Tonga & Tyler (T2)

VER : 3C

VM7

MODEL		Date	VM7I schematics change list				Model	DM3	MB			
							Page	FM	TO			
VM7I	07/26	P.24 Add MOD&HDD power switch circuit(reserved). P.25 Add MOD&HDD Enable pin. P.26 Add TP SMBUS pull up(RP36) P.31 Update Charge circuit per power update					1					
							2					
							3					
							4					
							07/27	P.5 Add C117,C119 per JM5 Schemtic change list update. P.7. Change L18,L19 to 10uH and C134,C146,C132 to 150V/2V and C95 to 2.2U/6.3V per JM5 Schemtic change list update. P.12 Change R326 to 20K, R323 to 100K C946 to 1U/10V per JM5 Schemtic change list update. P.13 Delete net"-PCICRI" per T2 non support it. P.14 Add C142,C143 per JM5 Schemtic change list update. P.17 Delete net"-PCICRI" and Q56,R438 per T2 non support it. P.20 Del net "ENPCMSPK" and D35,D36,R461 per non-need this function on T2 P.23 Change D39 to EVL=17-21SOC/TR8 and del net "-PWRLED2" per T2 support Signal power LED. P.25 USIO1.B12(GPIO70) add a net "HDDRSTEN" per primely HDD rst signal, Add a SPD1(ST34C02) per support on board DDR requirement. P.26 Del net "ENPCMSPK" per T2 non-need it and Add C121,C123 per JM5 schematic change update. P.27 Change R624 to 43K/F and R627 to

PCMCIA SOCKET

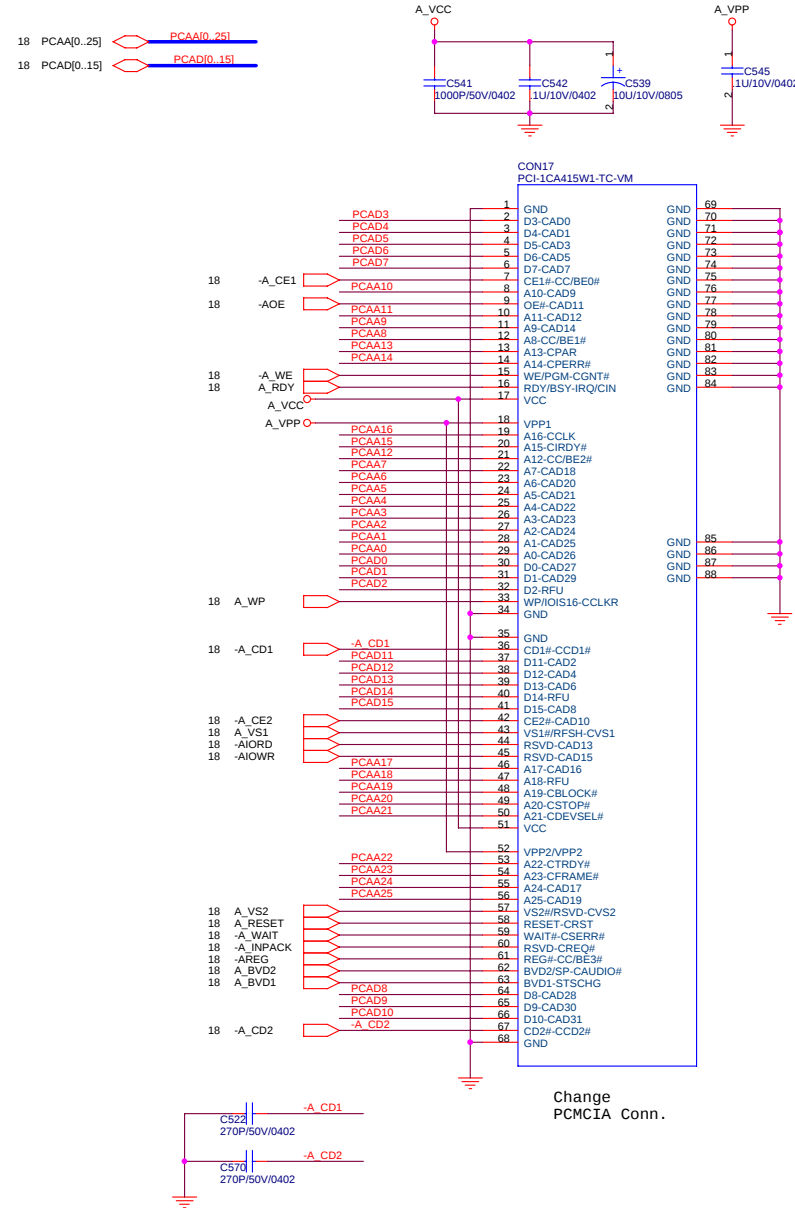
Change
PCMCIA Conn.

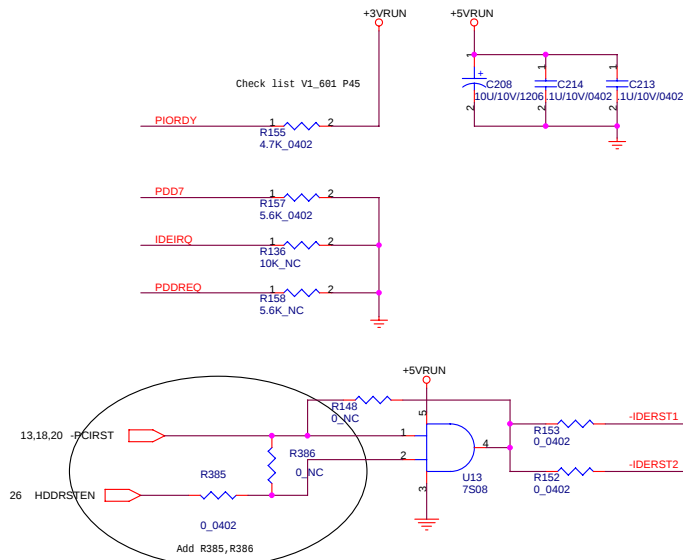
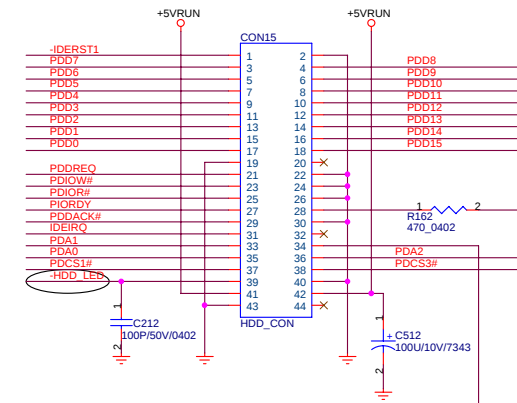
Del D19
13 PDD0
13 PDD1
13 PDD2
13 PDD3

Delete RN66,
R156, R159,
R160, R161,
R138 0ohm.

Per fix HDD&ODD issue.

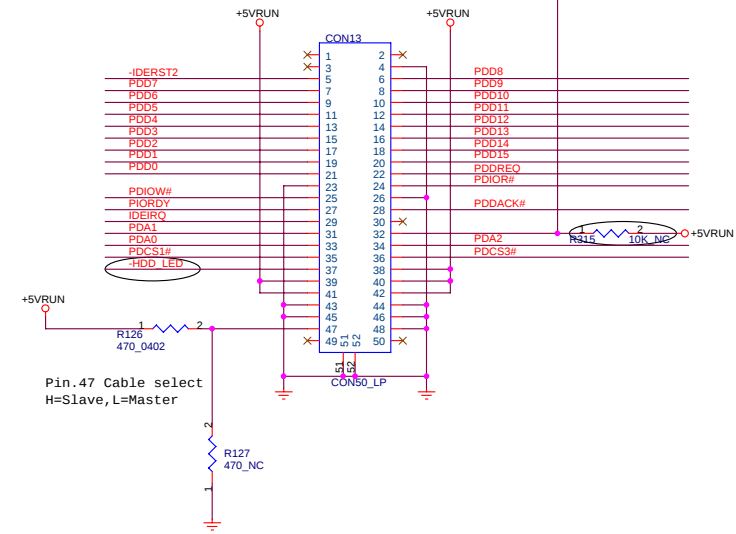
Del R163,R329 per HDD&ODD power link to '+5VRUN'

Del Q30,Q31,Q25,Q26,C509,C508,C493,C490,C483,R330,R301.
